**Stormwater Management Plan  
for  
Forest Heights Properties  
Didleau Subdivision**

**Preparation Date**  
May 17, 2022

Project Number  
2019.25

EPC Project No MS-206

Project No.: 18070  
Sheet: 4 of 4

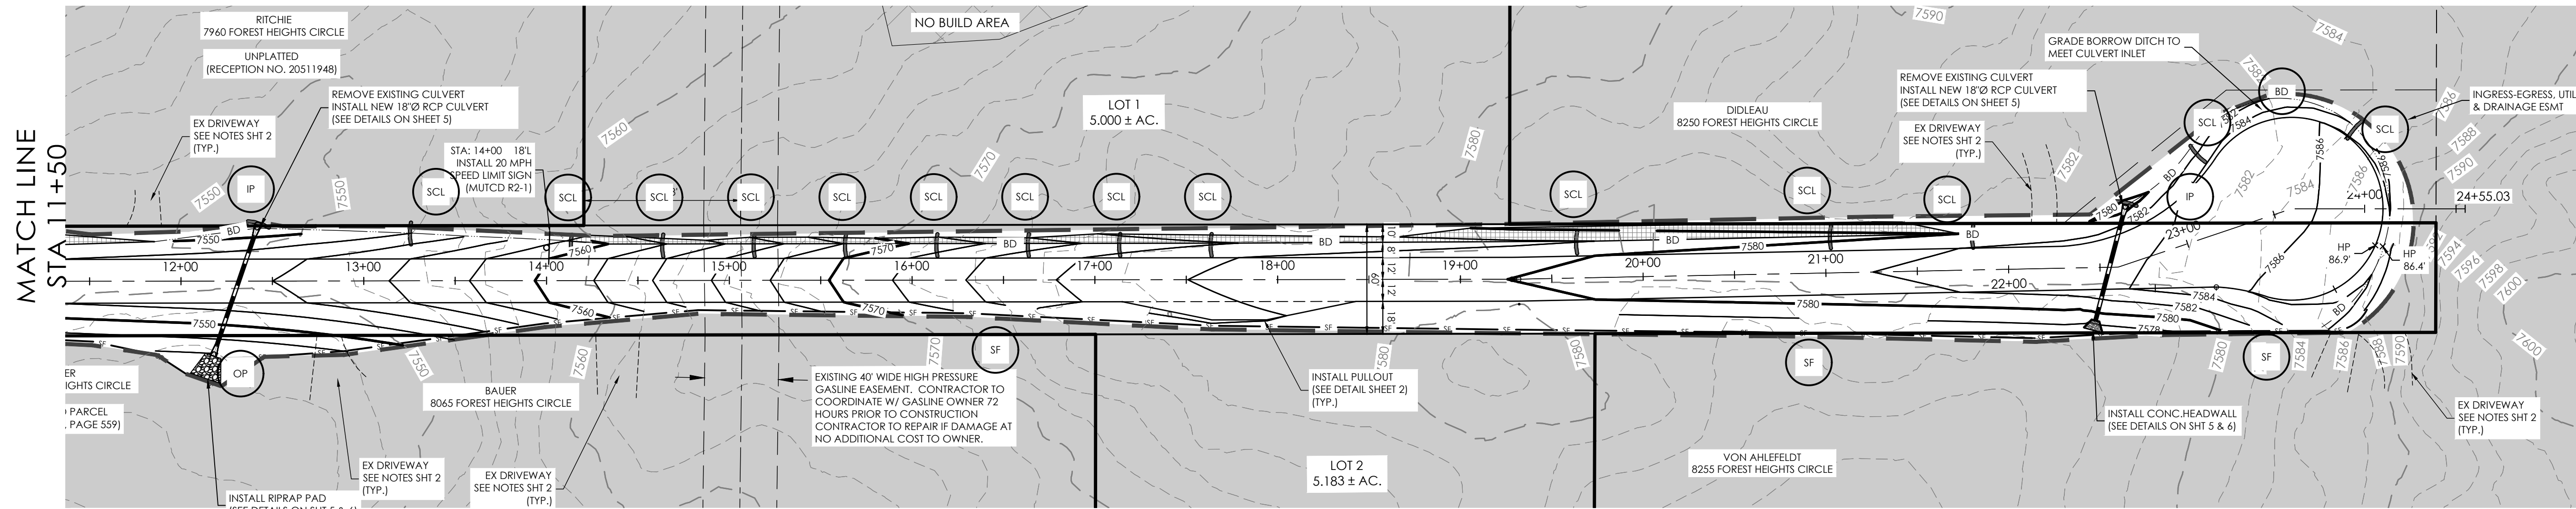
The BMPs however are phase. On the GEC Plan, you have initial and interim BMPs. So discuss that in this section.

GEC Plan only shows ECB on outside half of ditches. Revise plans to remove this discrepancy.

- and add a bullet for SCLs, which are shown on GEC Plans.
